NUREG-0575, Vol. 3  
Comments on  
Draft Statement  
Staff Responses

**HANDLING AND STORAGE  
OF  
SPENT LIGHT WATER POWER  
REACTOR FUEL**

COMMENTS ON THE DRAFT

STATEMENT AND STAFF RESPONSE

FIGURE 2: TOTAL SPENT FUEL POOL DECAY HEAT POWER WITH 1/3 OF REACTOR CORE REFUELED ANNUALLY

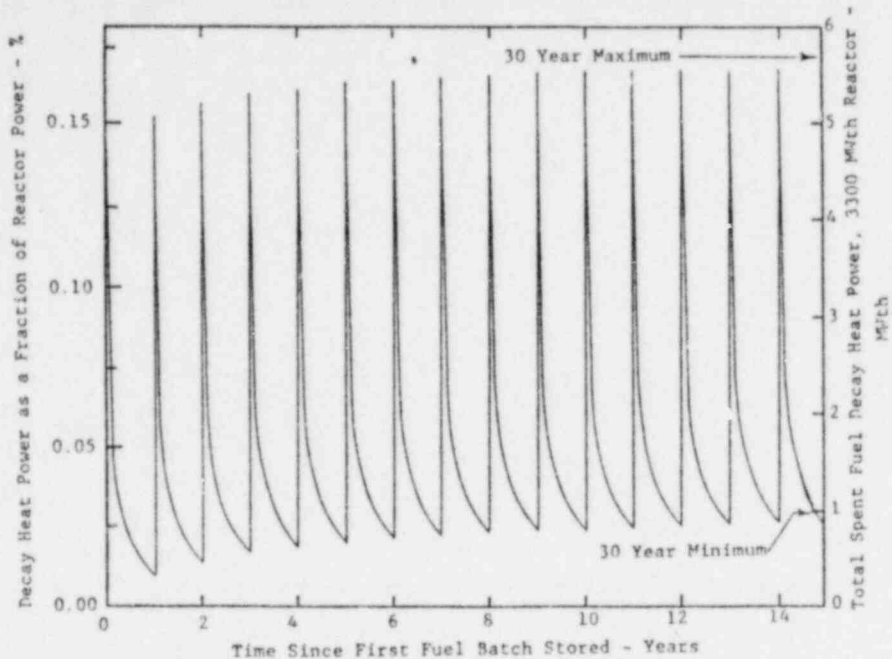
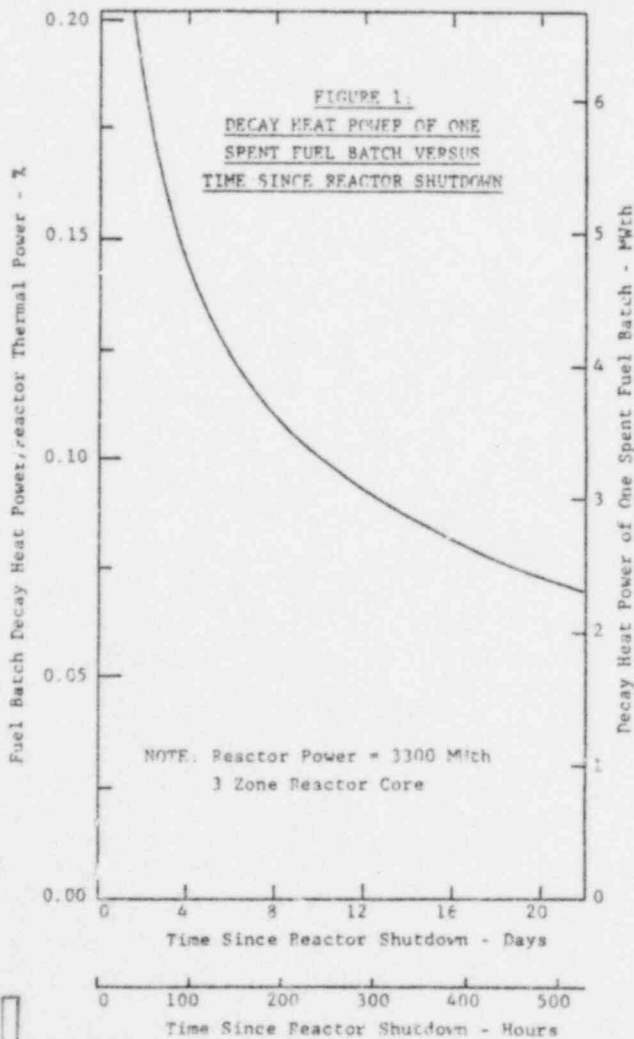
An empirical equation<sup>1</sup> was used to calculate the decay heat release from irradiated nuclear fuel. The maximum thermal loading on a spent fuel storage pool is determined principally by the time the fuel is allowed to cool before storing in the pool, see Figure 1.

Concerning routine, periodic fuel discharges, the spent fuel pool decay heat power will increase by a constant increment at the end of each reactor operating cycle. The increase in maximum heat loading is equal to the decay heat generation of the first batch, see Figure 2. Decay heat from the first batch of fuel stored decreases exponentially with time; thus, the maximum decay power (occurring at the time of fuel charging) approaches an asymptote and is

FIGURE 3: TRANSIENT WATER TEMPERATURE OF A TYPICAL SPENT FUEL POOL

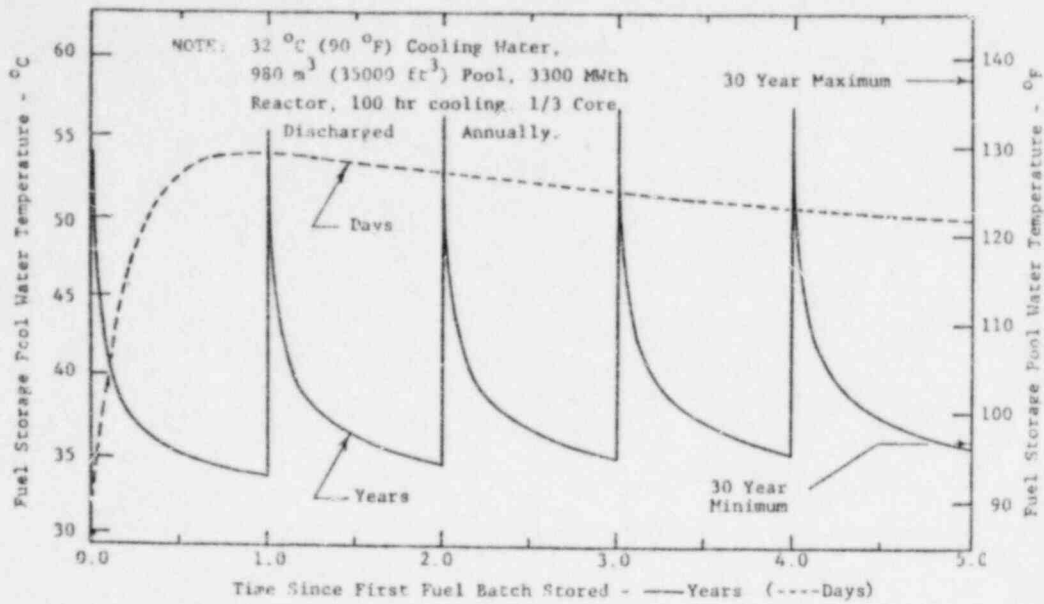
A spent fuel pool contains a large water inventory, typically 1100 m<sup>3</sup> (40,000 ft<sup>3</sup>), but may produce a 3-6 °C/hour (5-10 °F/hr) adiabatic heat-up rate. The pool's thermal capacitance is around 0.8 °C/MWth-hr (1.5 °F/MWth-hr). The maximum water temperature is determined principally by the heat removal system, the pool volume, and the pool thermal loading; it occurs about one day after fuel charging, see Figure 3.
